Noncompliant Weld Inspection Techniques

Line 114 Non Destructive Examination Final Report

Issue Date December 5, 2013

Figure 2 – Weld 270 Indication with measurement inset showing length of 0.157” (3.9mm)

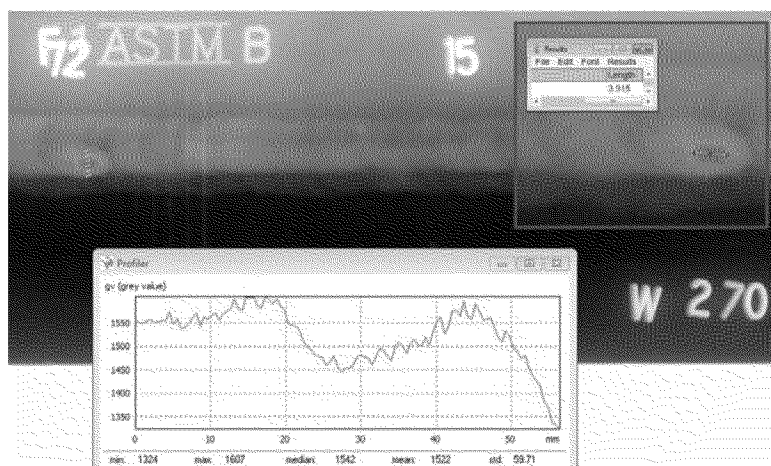
- 3.1 Weld 270, digitized in the region of interest is depicted in Figure 2. Here it can be seen, due to low change in density which is less than the adjacent parent material, and the presence of a halo, that the indication is one of Burn-Through (BT), and is acceptable per section 9.3.7 of API-1104. The weld repair process confirmed this result where the indication was found at the root.

Figure 3 – Weld 311 with acceptable BT length of 0.141” and acceptable small pores

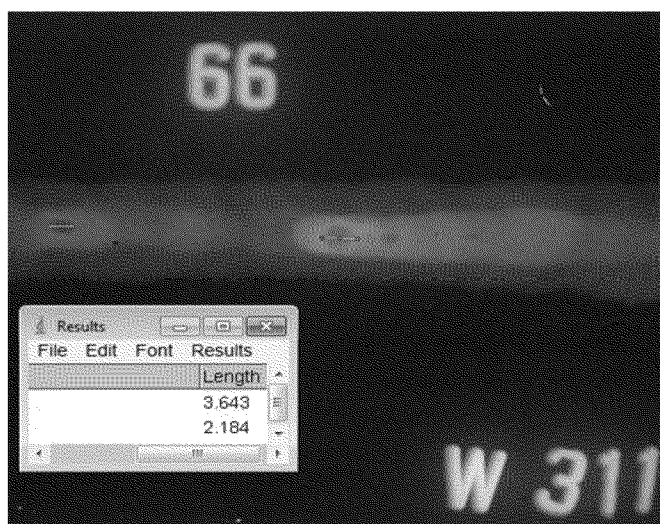
3.2 Weld 311, digitized in the region of interest, is depicted in Figure 3. Similarly we have one indication of burn-through and 3 small pores, all of which are acceptable per sections 9.3.7 & 9.3.9 of API 1104. For both welds 270 and 311, the repair process had to proceed to the root before the indications were eliminated, confirming that they were caused by burn through.

Figure 4 – Weld 162 with acceptable indications of undercut

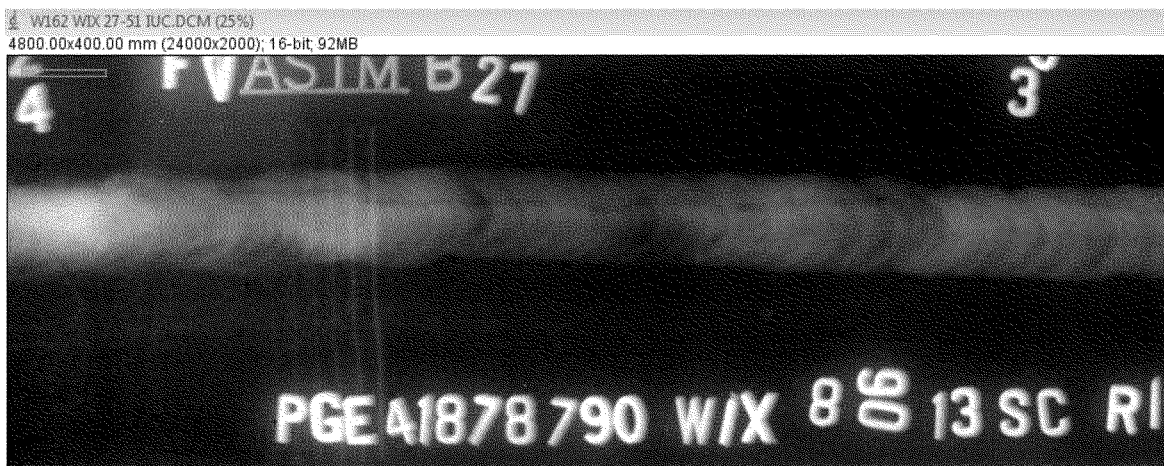
3.3 Weld 162 indication was digitized as shown below in Figure 4. Radiographic density measurements indicate that no portion of the indication has an indication of undercut which is greater than 0.016” deep, indicating that it is acceptable per section 9.3.11& 9.3.7 of API 1104.

Figure 5 – Measured IUC on W162 depicted in Figure 4

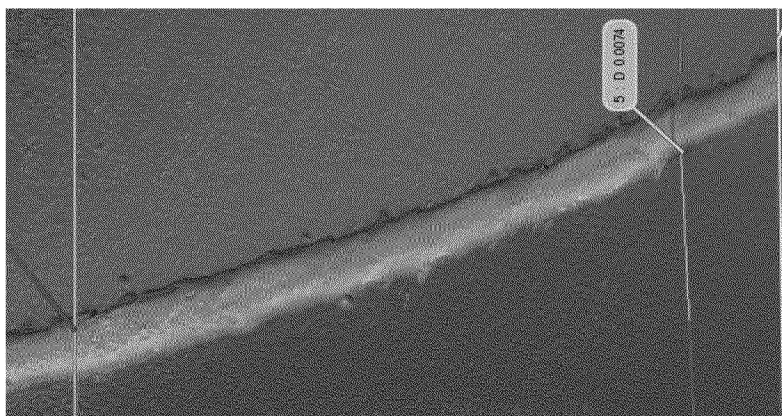
- 3.4 To validate the digital radiographic measurements, external visual, UC gaging and dial indicator measurements revealed that only small areas within the called ROI (25-29) had bottoms estimated below the adjacent parent material surface. Measurements had thus low repeatability due to topography. This result led to the decision for the Creaform photogrammetry with its calibrated 40 micron spatial resolution and accuracy to within 0.002”.
- 3.5 Creaform photogrammetry results were obtained for the radiographic ROI (25-29 in Figure 4). The measurements confirm that no portion of the indicated area of concern radiographically, has a depth greater than 0.016 inches, and is therefore acceptable per sections 9.3.11 & 9.7. Figure 5 below depicts worst case of 0.0074” in radiographic ROI.

Figure 1 – Assessment of Weld 760 IUC region of interest

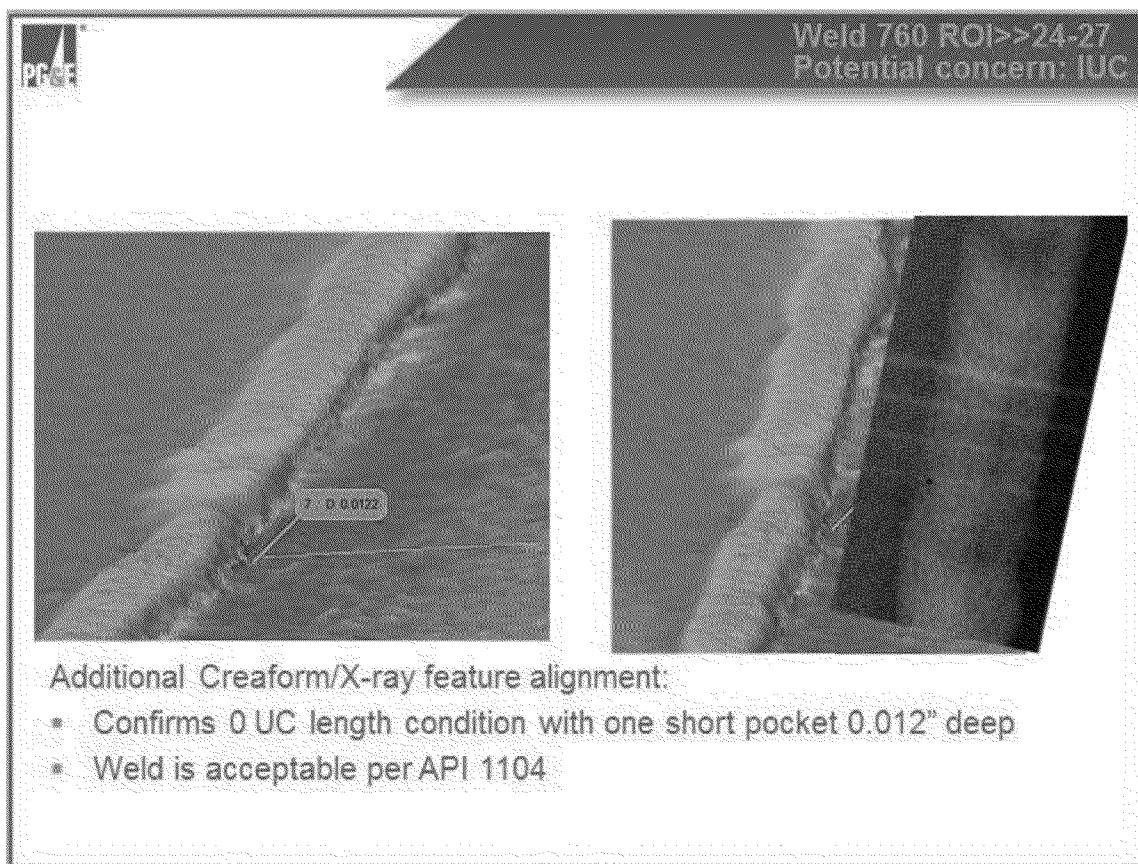
3.5 Creafom photogrammetry results were obtained for all the radiographic ROI's. The criteria applied to these results were API 1104 section 9.7, Table 4, "Maximum Dimensions of Undercutting". Applying the further criteria of depth from this requirement, to the documented radiographic and visual measurement data for length, all welds were found acceptable. Figure 2, from slide 5 in Appendix I, summarizes the typical physical condition for the audit identified indications of concern.

Weld 760 cited for indications of internal undercut from 24-27

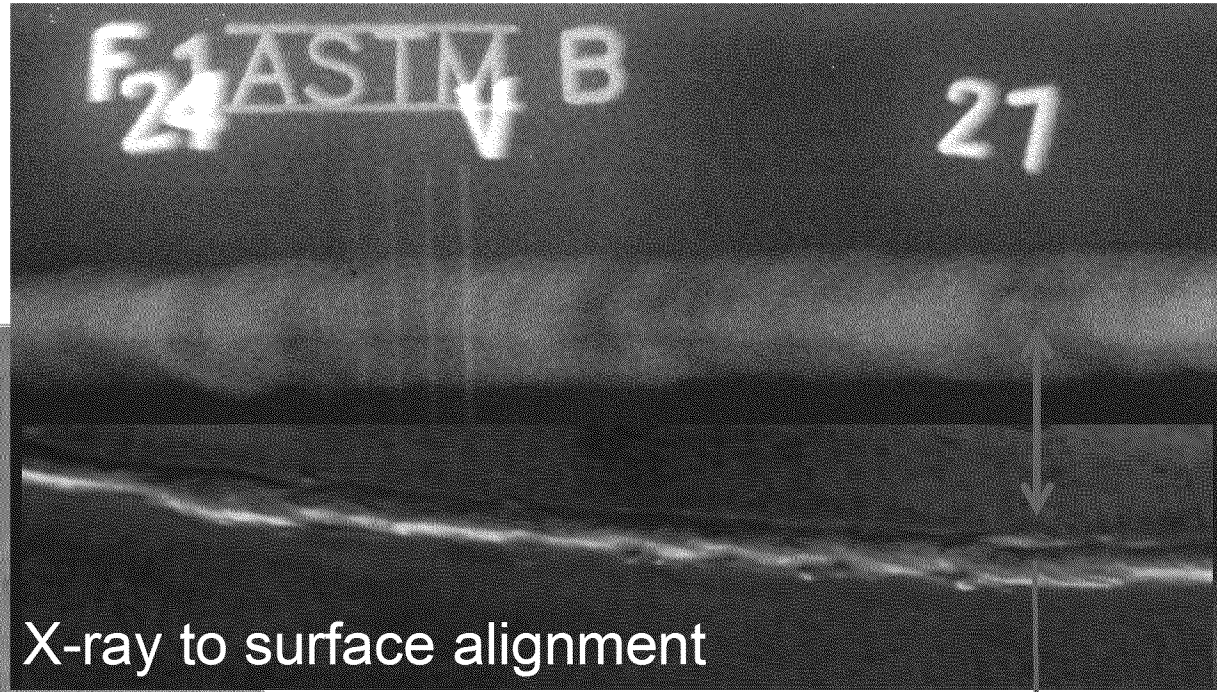
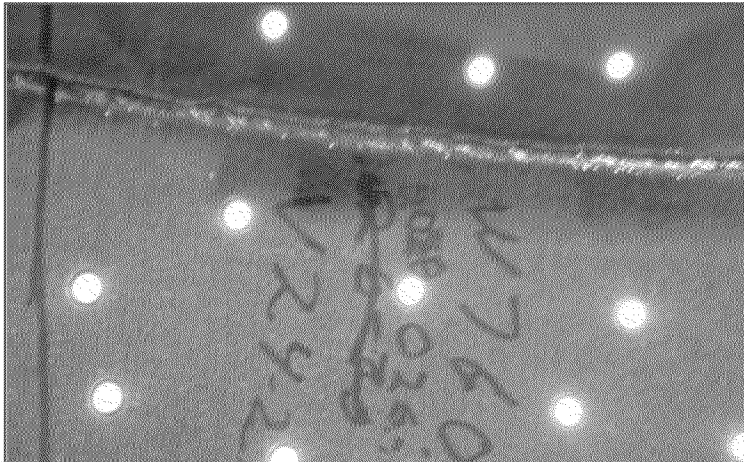
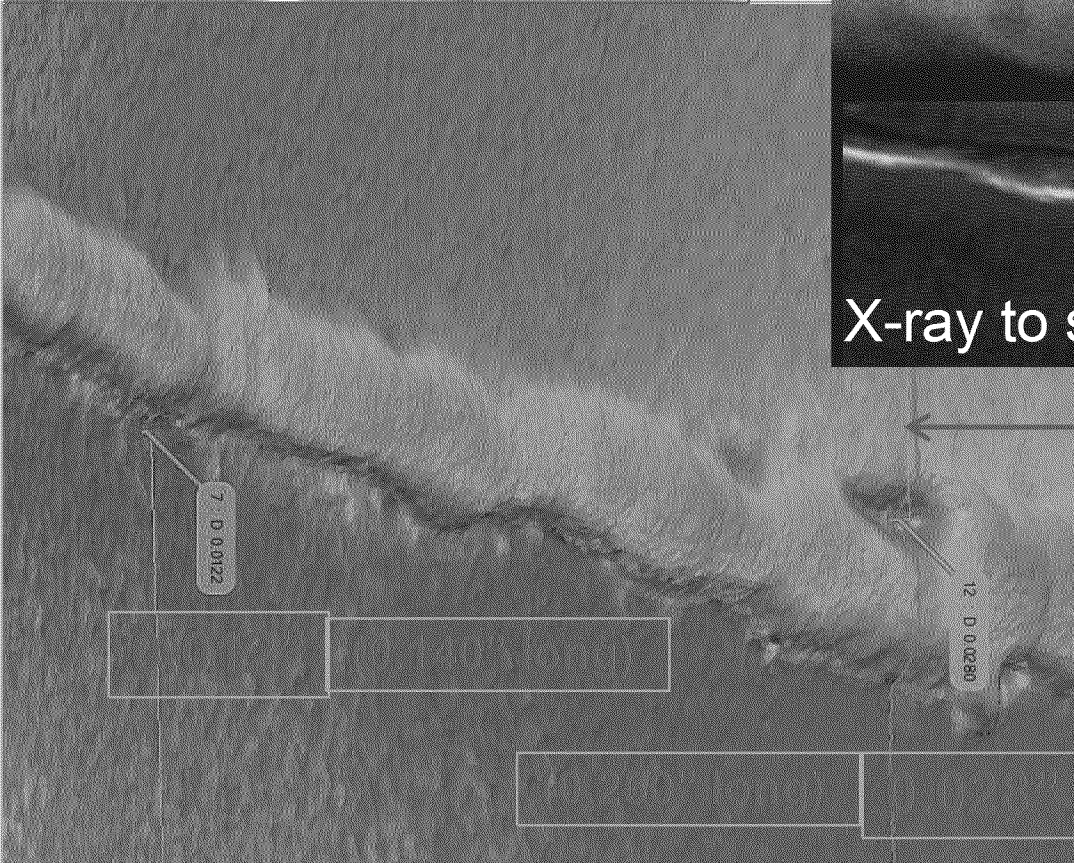
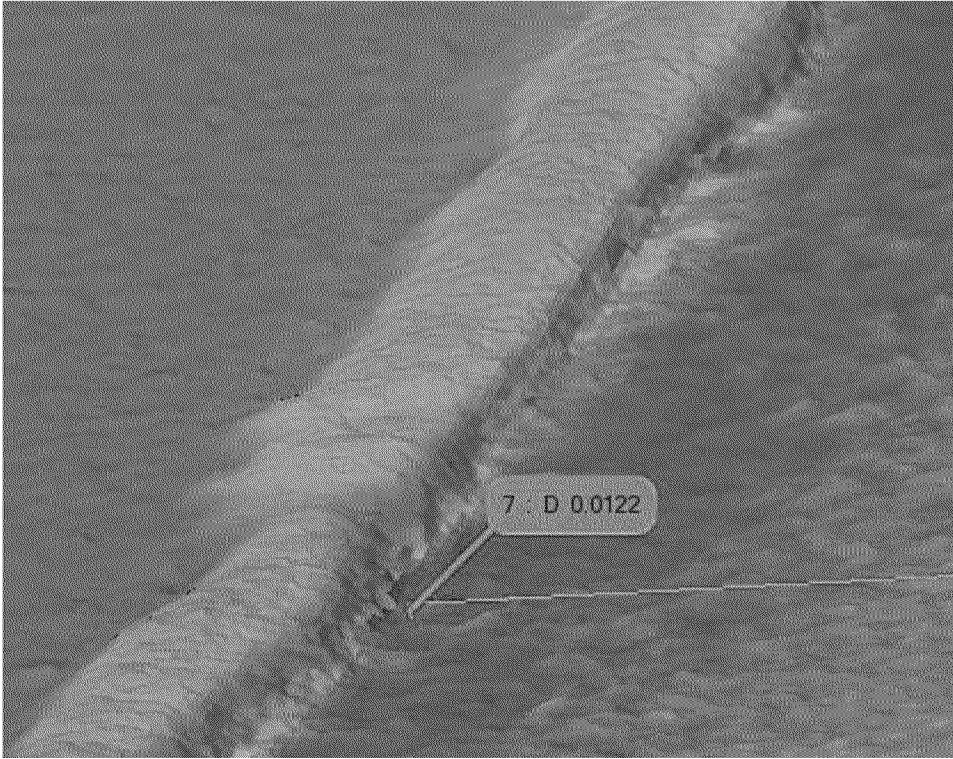
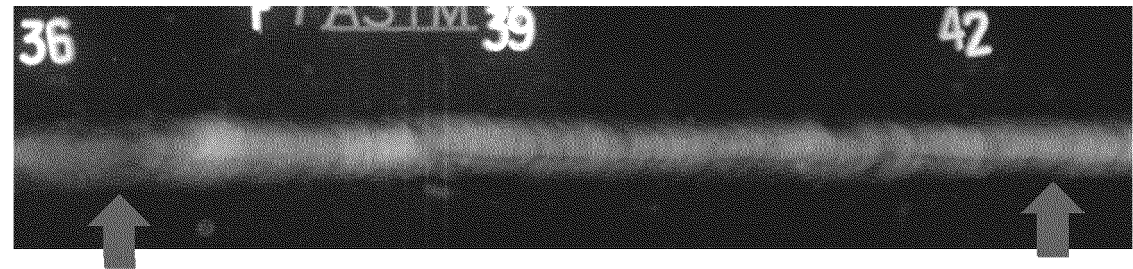
RT estimated depths of 0.012 – 0.028 inches

Confirms indications are mostly diffraction effects on minor hi/lo condition with 0 UC

Weld is acceptable per API 1104

- * Confirms 0 UC length condition with one short pocket 0.012" deep
- * Weld is acceptable per API 1104

Weld 770 cited for indications of internal undercut from 36-42

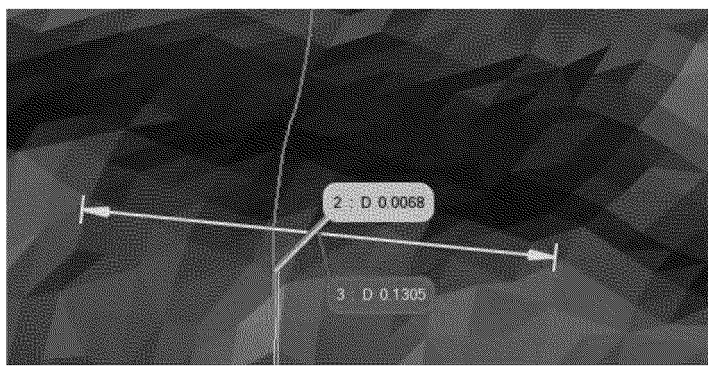
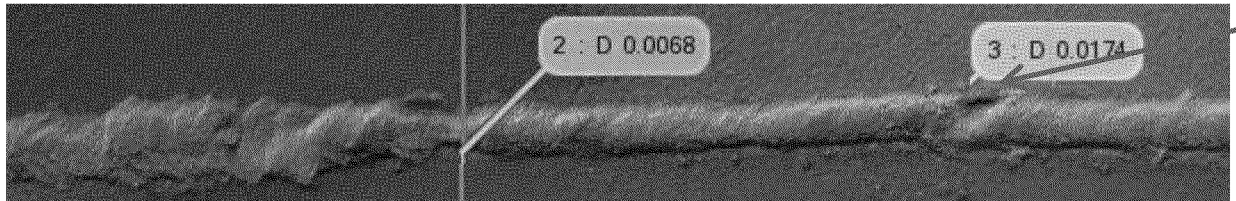
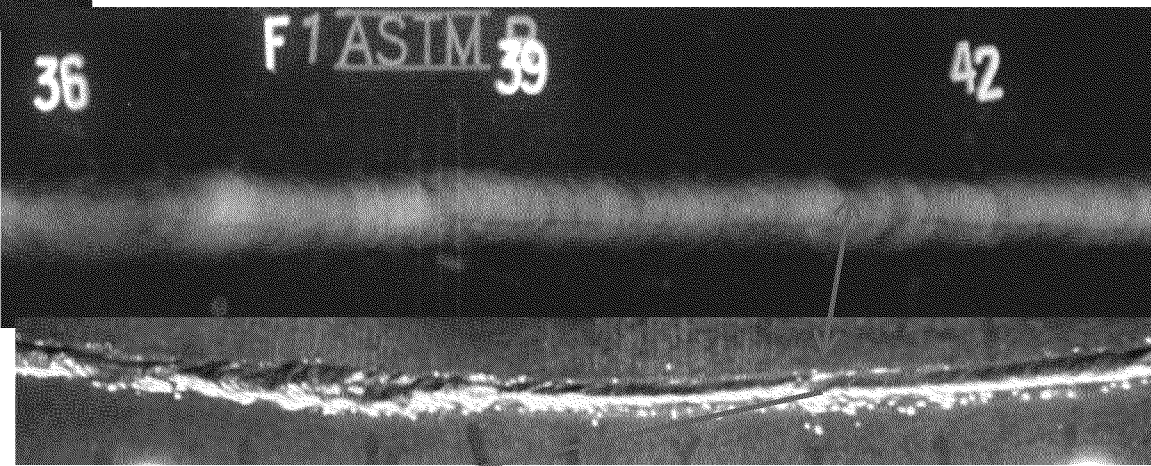
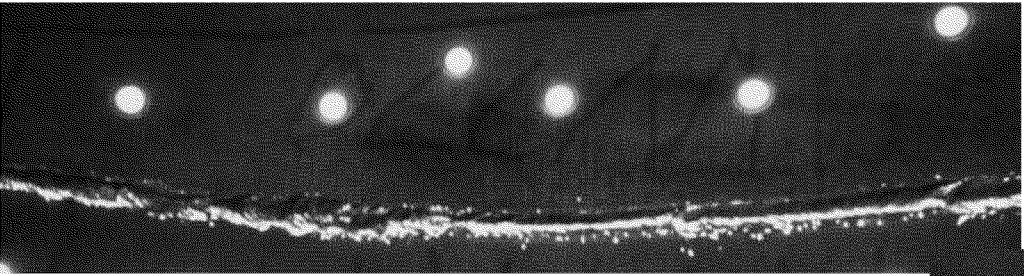
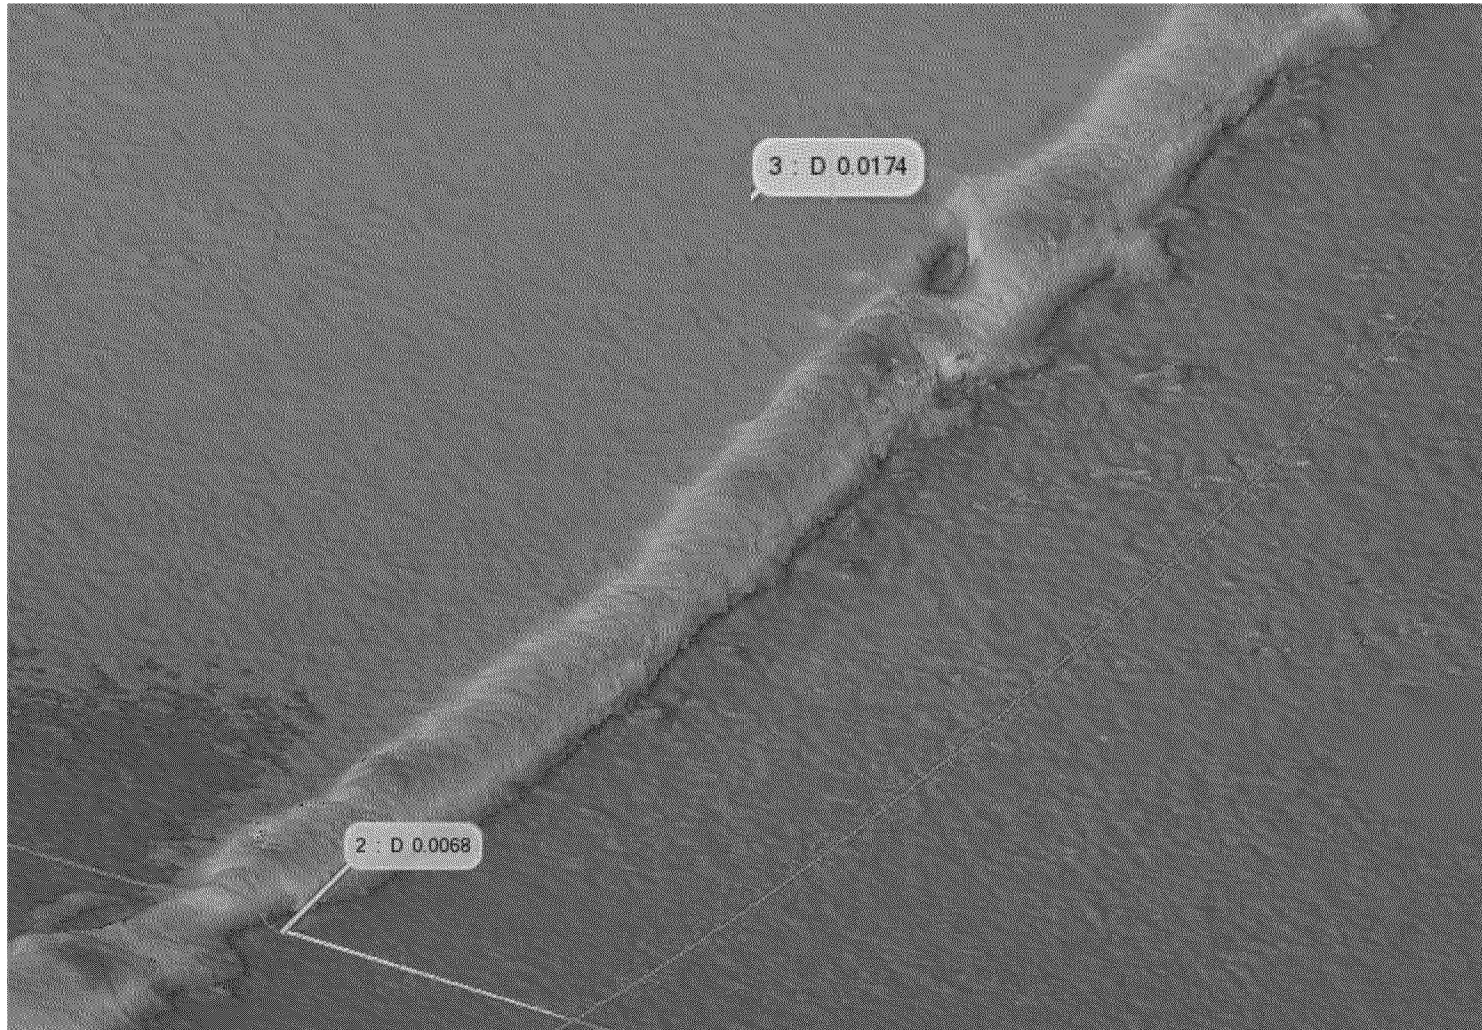
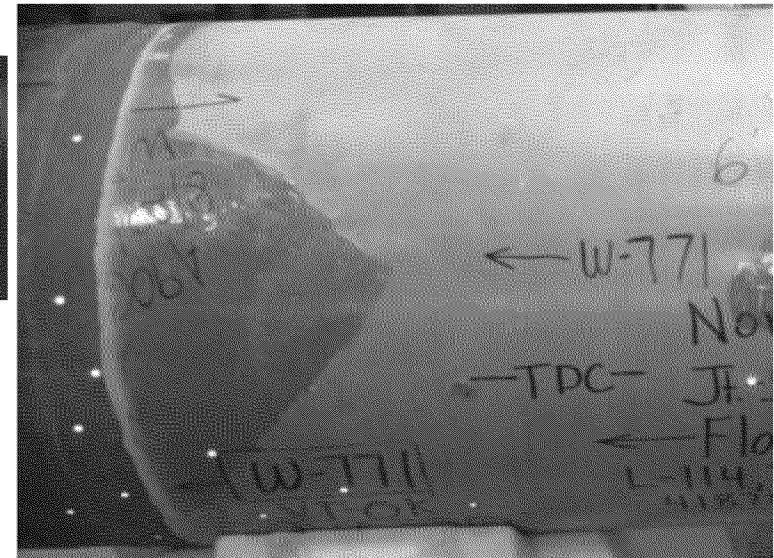
RT estimated depths of up to 0.008 inches

- Confirms indications are, in the majority, diffraction effects on minor hi/lo condition with 0 UC
- One small pocket observed at 0.007" deep x 0.130" long
- One unrelated pocket opposite ROI of 0.017" deep x 0.195" long
- Weld is acceptable per API 1104

- * Confirms UC indication is diffraction/"shadowing" from high/low condition
- * Weld is acceptable per API 1104
